37/03-03EEEE 7114 Poplar Avenue
Takoma Park Historic District

HISTORIC PRESERVATION COMMISSION STAFF REPORT

Case Number: 37/03-03EEE

PROPOSAL: Add windows, French doors, and shed dormers

SCHEMATIC SECTION

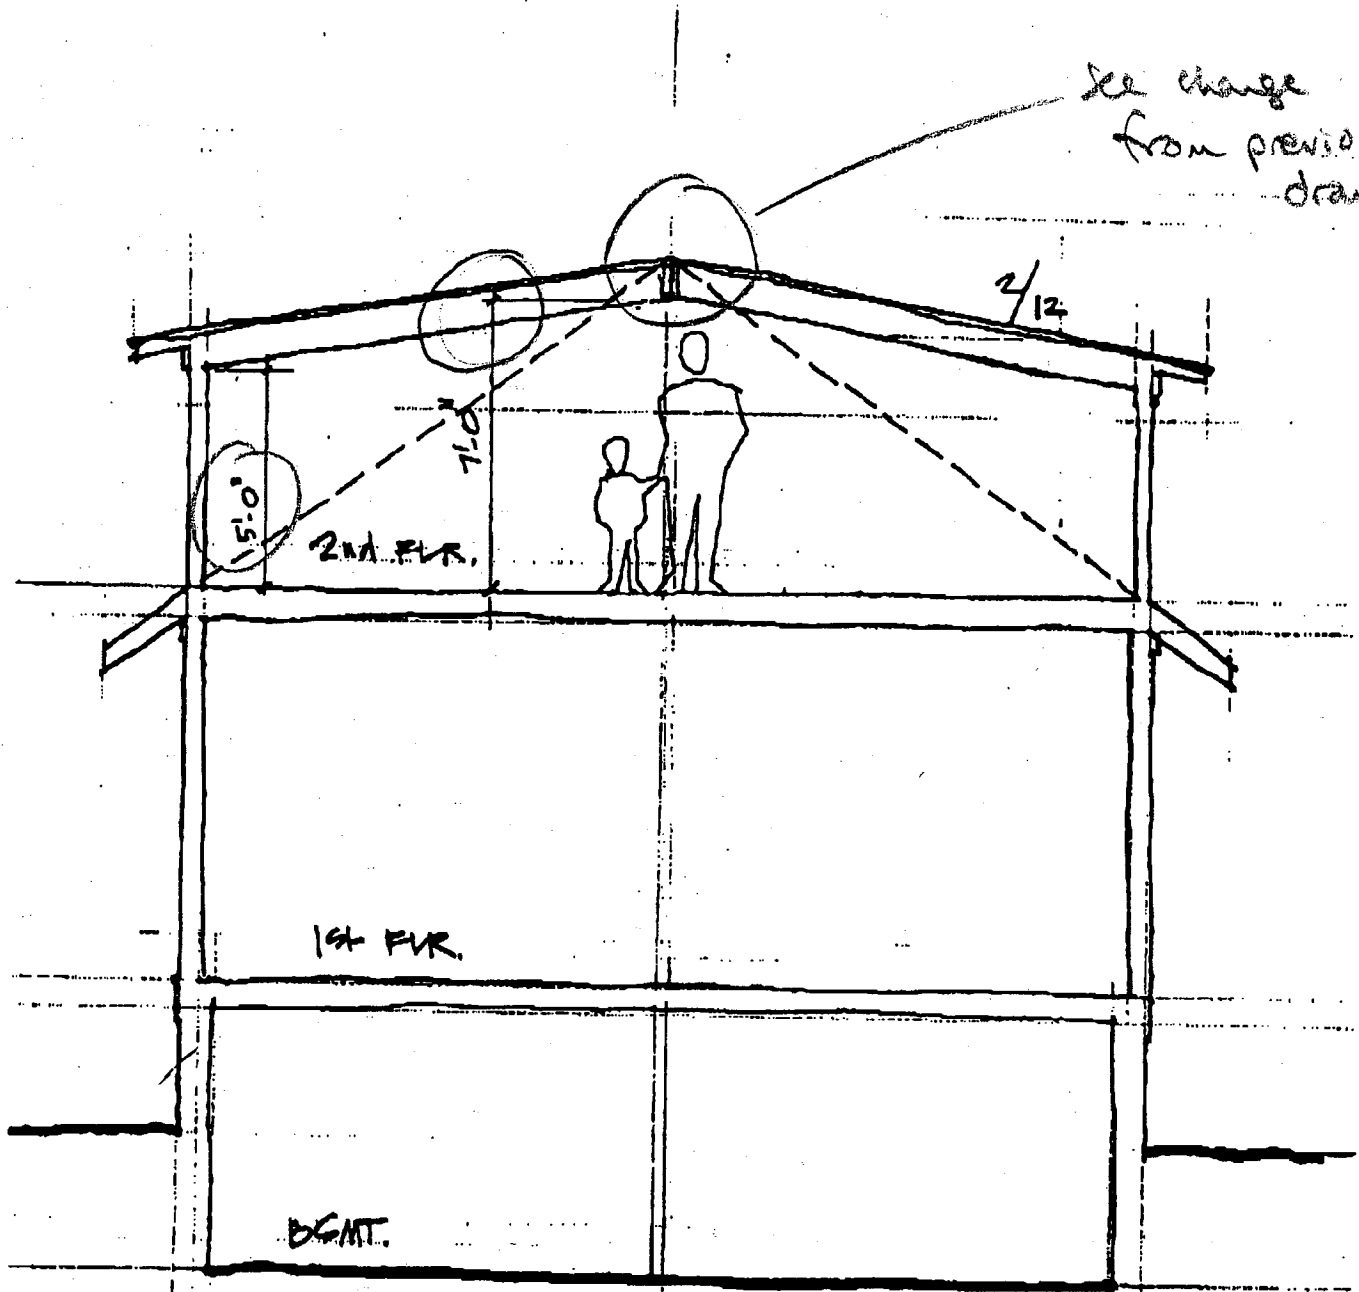
See change from previous drawings

Proposed West (rear) Elevation

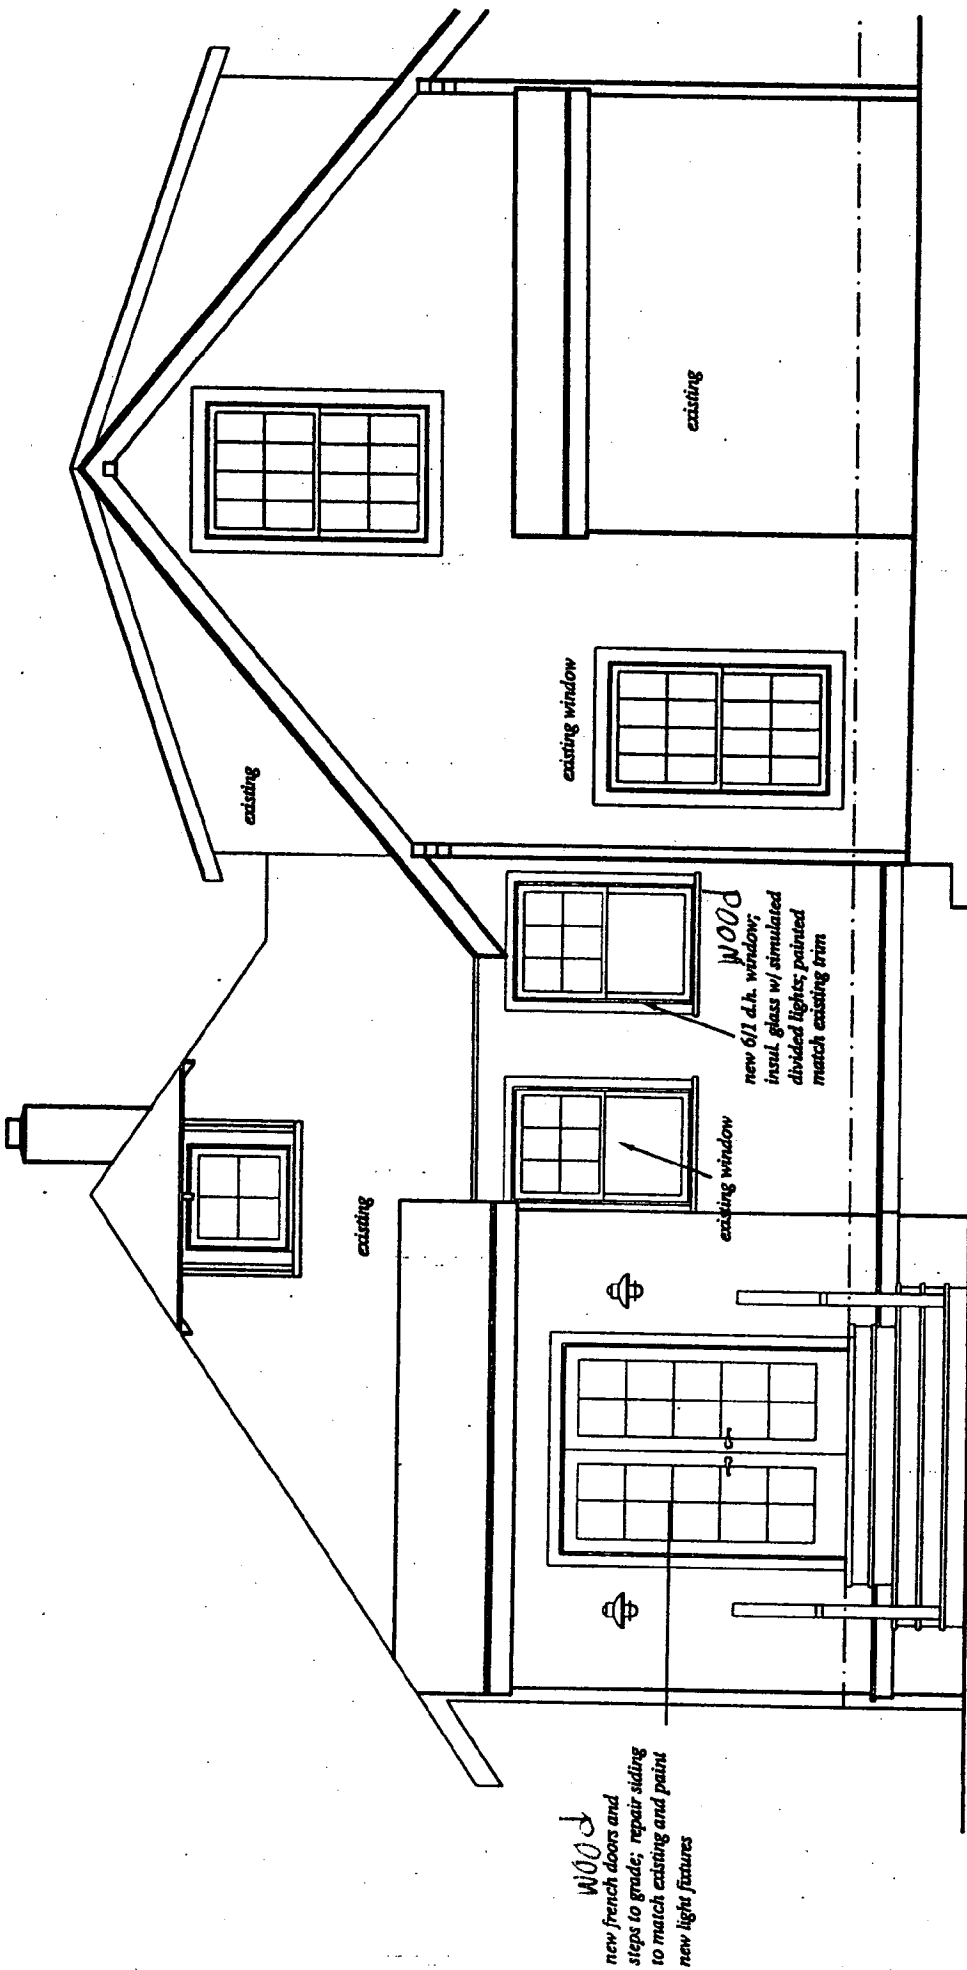
The HPC agreed last night that you can purchase clad-wood patio doors for the rear elevation of your house. Attaching this email to your plans should be sufficient and you can write in the word "clad" on your drawings, but if you need me to mark up the plans I can.

WOOD
 new french doors and
 steps to grade; repair siding
 to match existing and paint
 new light fixtures

WOOD
 new 6/1 d.l.h. window;
 insul. glass w/ simulated
 divided lights; painted
 match existing trim

DIXON RESIDENCE ALTERATIONS
 7114 TOPLAR AVE. TAPOMA PARK, MD.
 SECOND FLOOR PLAN
 15 OCT. 03
 MERM ARCHT/RS

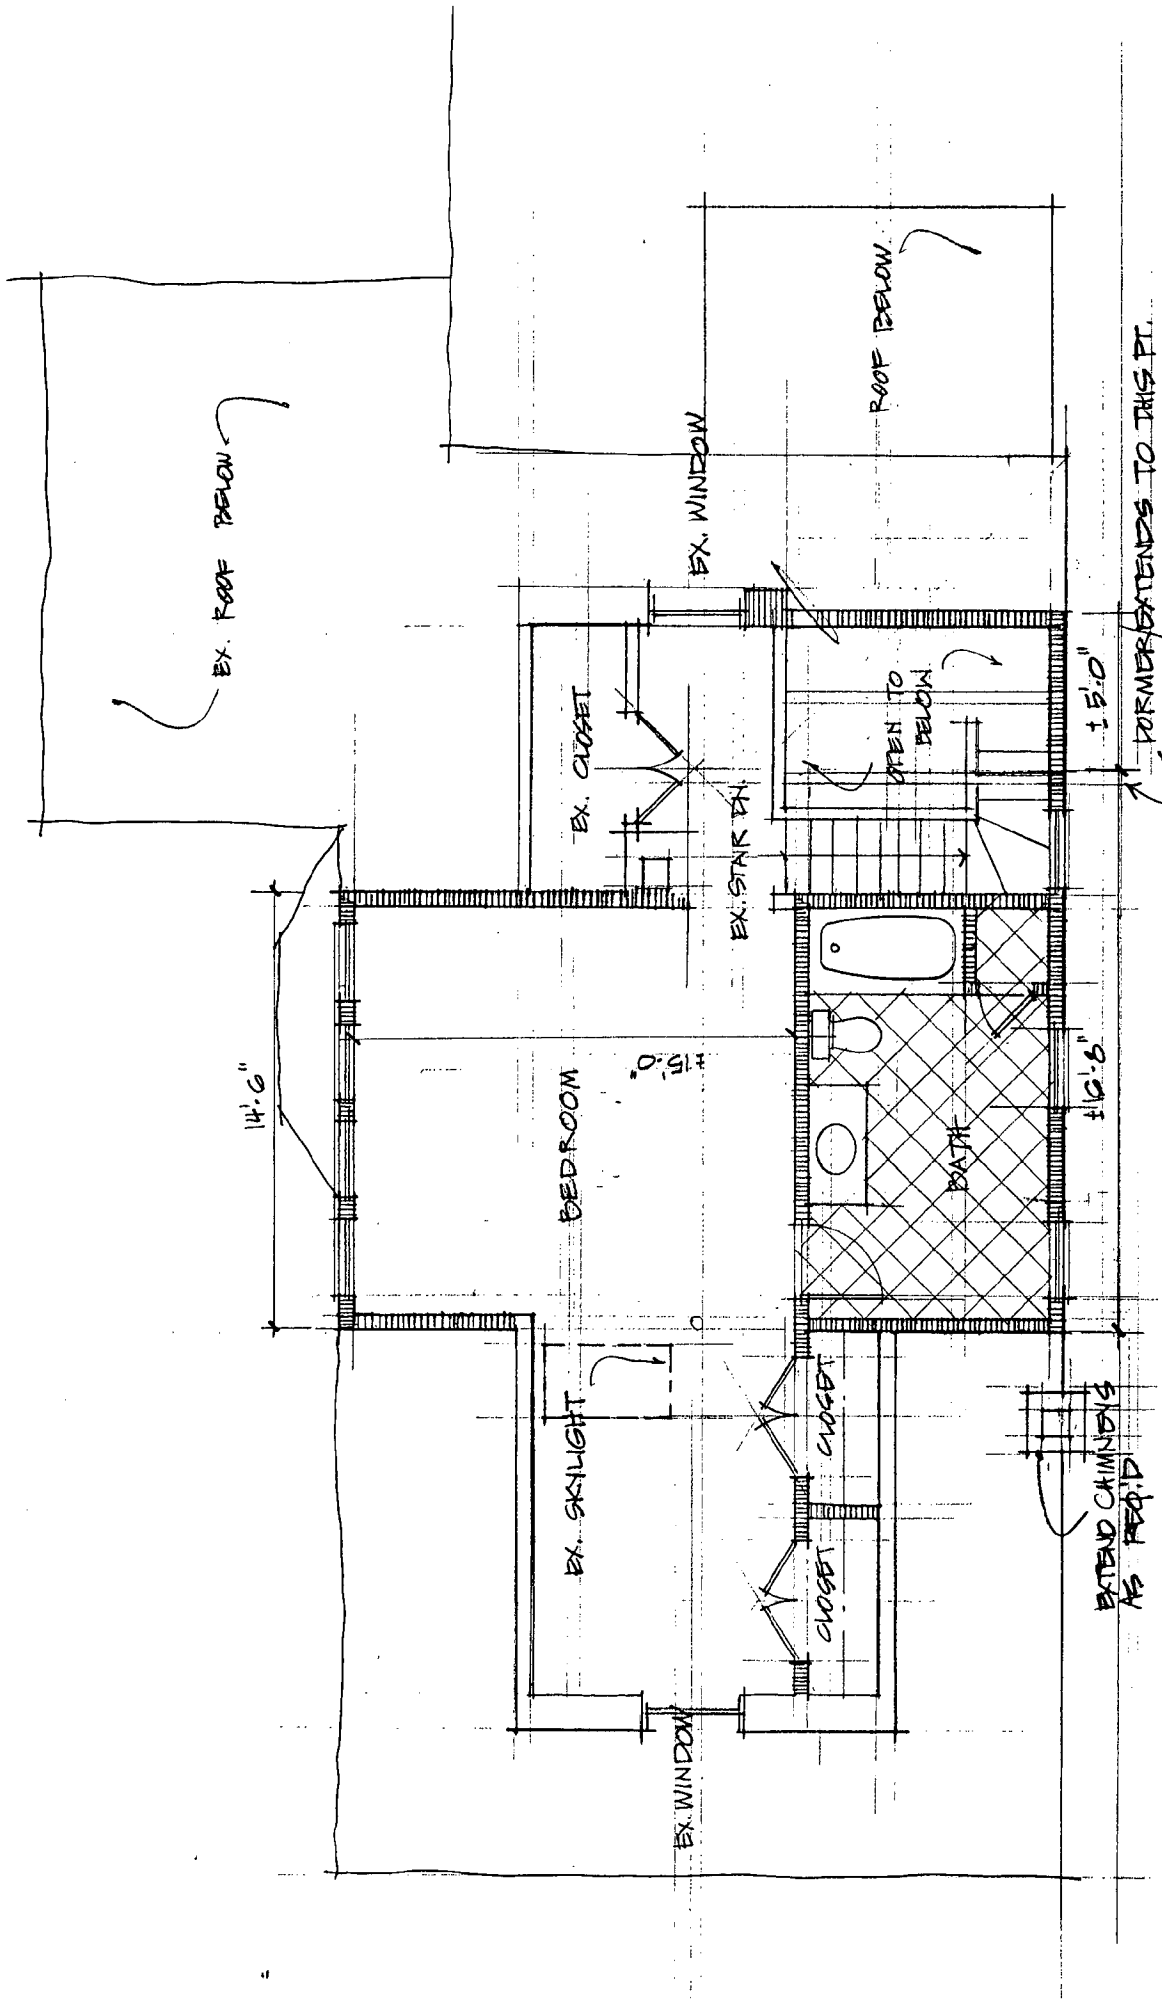
EXTEND CHIMNEYS AS REQ'D
 FORMER EXTENDS TO THIS FL.

DIXON RESIDENCE ALTERATIONS

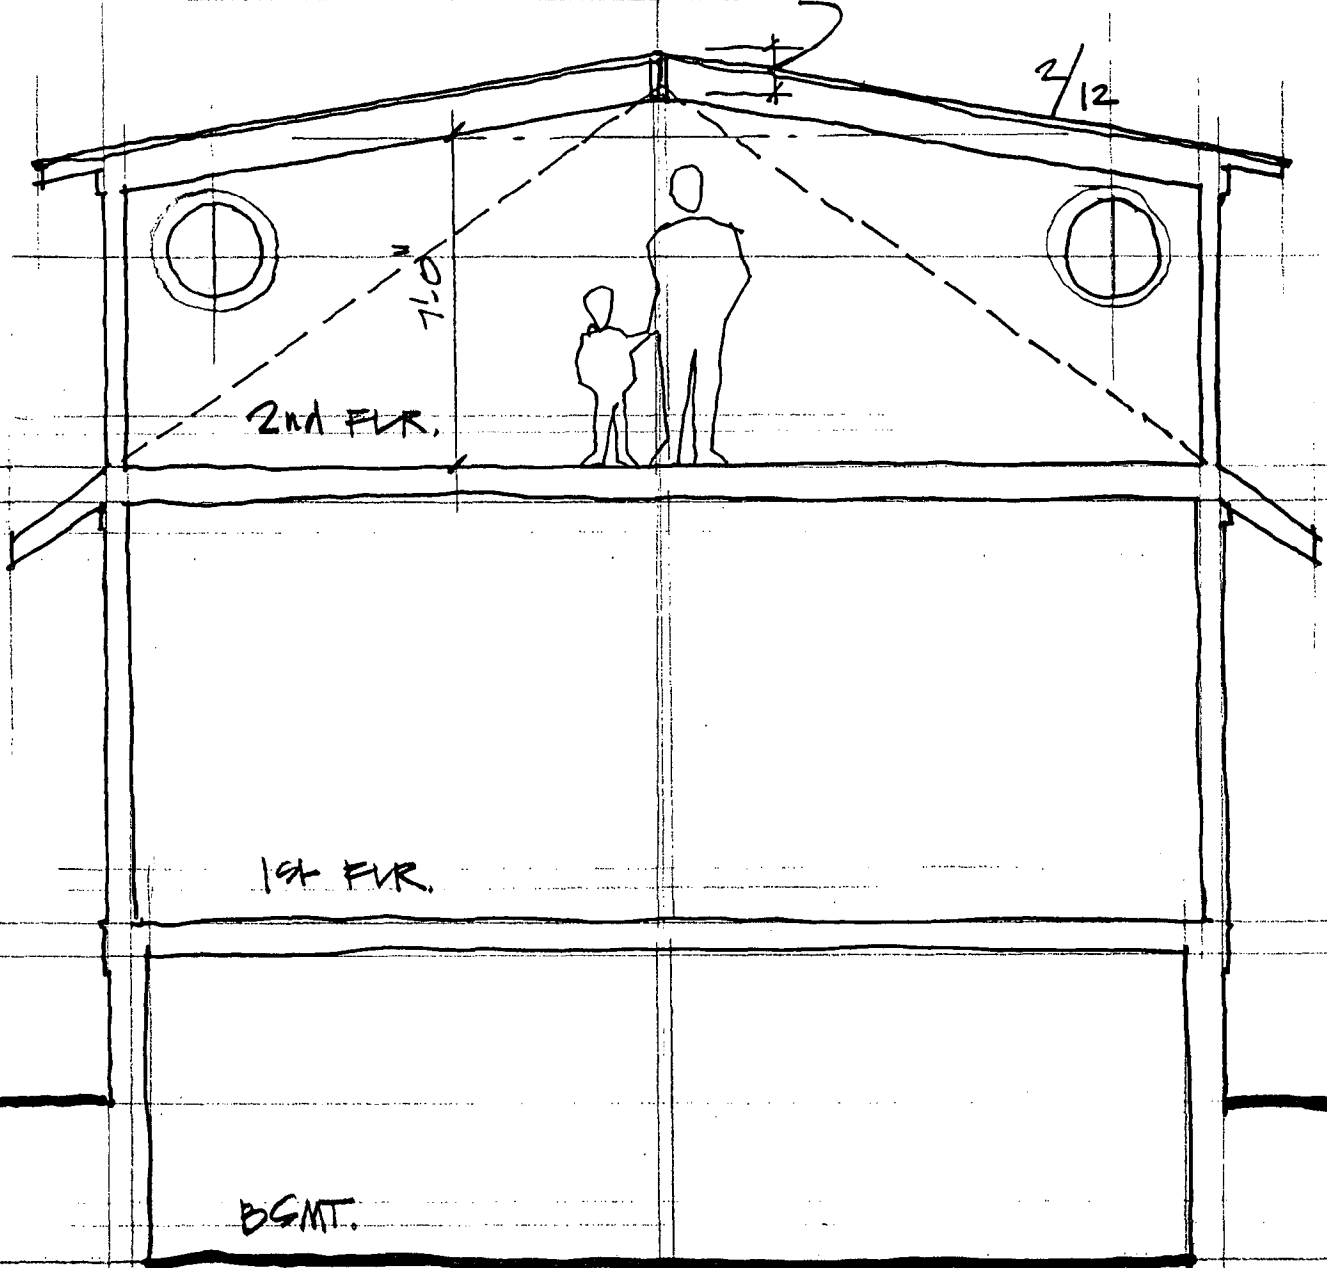
change to 3/12 - give me 35 s.f. area with area being
shallower

1. A 3/12 pitch as opposed to a 2/12 pitch on the shed dormers in order to lower the slope of the roof while at the same time....
2. Exposing the roof rafters on the inside of the new space, using lightweight steel roof framing and exterior insulation, all as a means to get enough interior volume to satisfy fire code and egress regulations as per Smart Code Section 05.16.04, the section on interior space dimensions for Modifications.
